DEVELOPMENT REVIEW COMMITTEE (DRC) COMMENT REPORT

PROJECT NAME: 1101 North Federal Highway Mixed-Use Residential Development

CASE NUMBER: UDP-S21014

REQUEST: Site Plan Level III Review: Conditional Use for Mixed Use Development with Allocation of 247 Residential Flex Units, 14,061 Square-Foot Office Use, 13,746 Square-Foot Retail Use, and 7,686 Square-Foot Restaurant Use with Associated Shared Parking Request

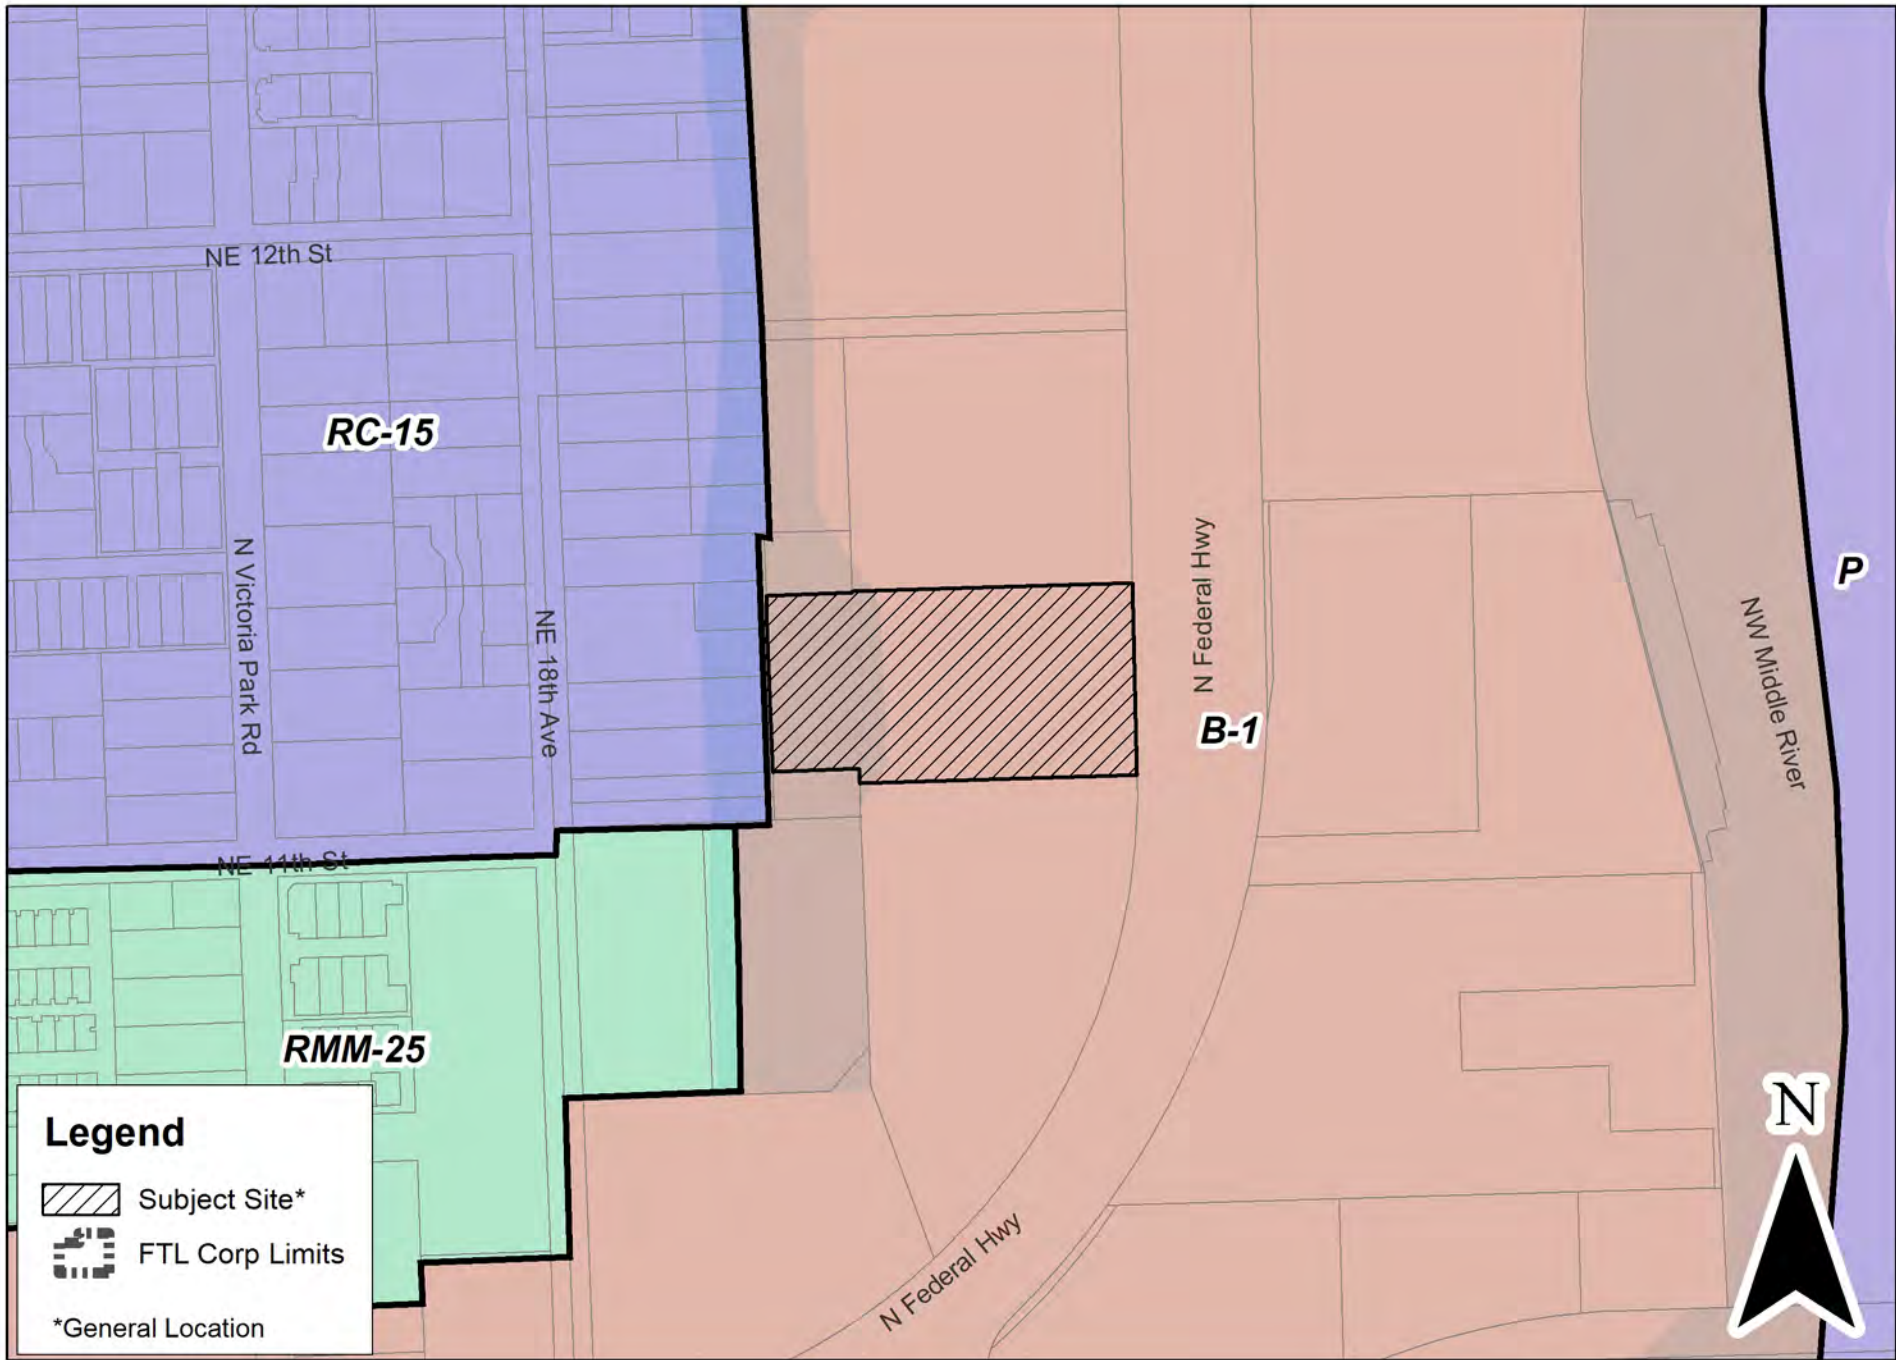
- 6) As proposed, the building footprint and overall site layout leaves minimum space for adjustments, limited space for pedestrian and resident respites, and lacks overall connectivity of uses both internally and externally to the public realm. The site layout should be re-evaluated to: (1) provide stronger building presence that aligns with ground level uses or activities, (2) create significant building entrances that aligns with proposed uses, (3) increased articulation for open space or dog park or other pedestrian urban space, (4) reduce amount of vehicular use area by consolidating such, and (4) reduce development program. Furthermore, the building should contain high quality material on elevations facing the public realm and neighborhood where the use of stucco should not be counted as high quality building material. See images below for reference.
